SERVICE BULLETIN SB99.3A

Machines/Models: SL26/30RT, SL26/30SL

**Serial Numbers:
11200-12180**

PURPOSE: To enhance pressure protection of drive motors.

FIGURE 1

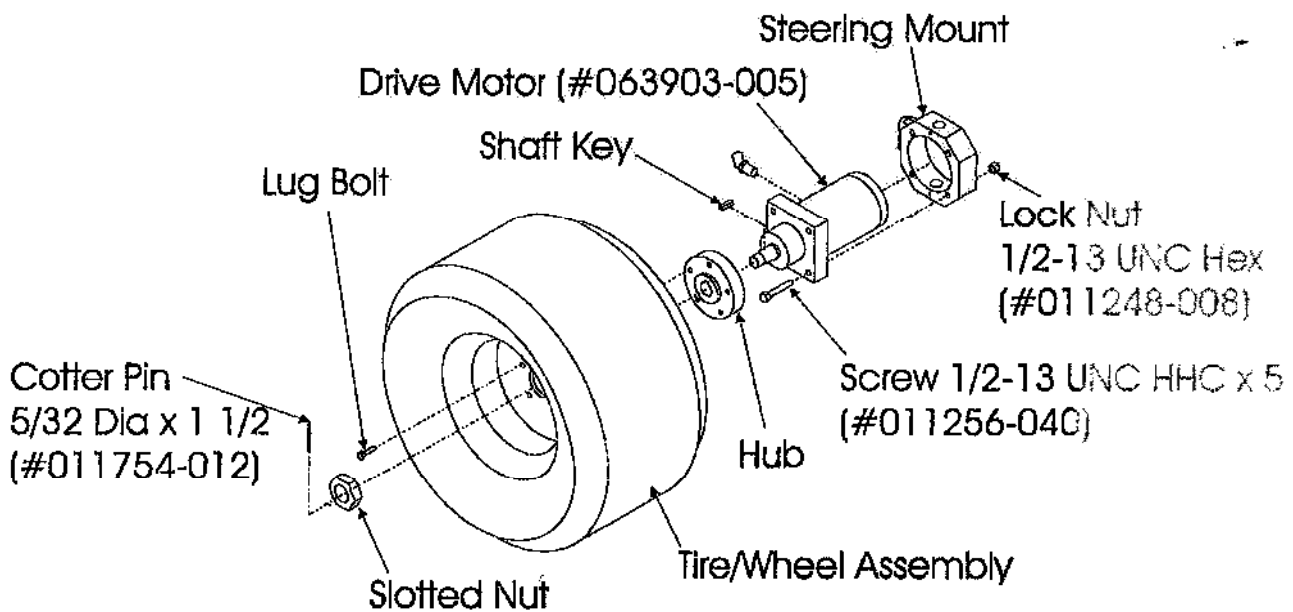
OPERATION REQUIRED: Replace front drive motors and existing hardware.

PROCEDURE: Read all instructions thoroughly and refer to Figures 1 before starting.
(Reference Service & Parts Manual)

1. Position the Drive Motor (#063903-005) into the Steering Mount and secure with Screws (#011256-040) and Nuts (#011248-008). Torque nuts to 75 ft./lbs (102Nm).
2. Reinstall the adapters to the Hydraulic Motor.
3. Reinstall the hose assemblies.
4. Thoroughly clean the motor shaft and hub bore of all grease, paint and foreign material.
5. Reinstall the Shaft Key, Hub, and Slotted Nut. Torque each Wheel Hub Nut to 350 ft./lbs. (475 Nm). Align the slot in the Nut with the hole in the shaft and insert the Cotter Pin (#011754-012). DO NOT back off the Nut to align.
6. Reinstall the Wheel and Lug Bolts onto the Hub. Torque the Lug Bolts to 90 ft./lbs. (122 Nm).
7. Remove the jack stands used to block the wheels. Lower the jack and remove.
8. Operate the drive system to check for leaks.

NOTE: No adjustment is required on Drive Motor Relief.
